PRODUCT/PROCESS CHANGE NOTICE (PCN)

PCN #: SG0703-02R1 Product Affected: See Listing in Attachment 2 Date Effective: July 2, 2007	DATE: April 18, 2008	MEANS OF DISTINGUISHING CHANGED DEVICES: <input checked="" type="checkbox"/> Product Mark <input type="checkbox"/> Back Mark <input type="checkbox"/> Date Code <input type="checkbox"/> Other
---	-----------------------------	--

ATTACHMENT 1 - PCN #: SG0703-02R1

PCN Type: Audio Codec Top Mark Format Change

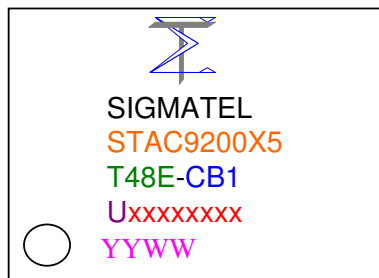
Detail of Change: All 48L QFP Audio Codec devices will use the IDT standard top mark format. There is no change to device design, process or technology.

Details: Changing from a 6 line format to a 4 line format

- Line 1: Removed SigmaTel logo
- Line 2: Replaced SIGMATEL name with IDT name
- Line 3: Part number line, no change
- Line 4: IDT package codes used instead of SigmaTel

Line 5: Lot code replaced by IDT format.

Line 6: removed date code and is added to the lot code line
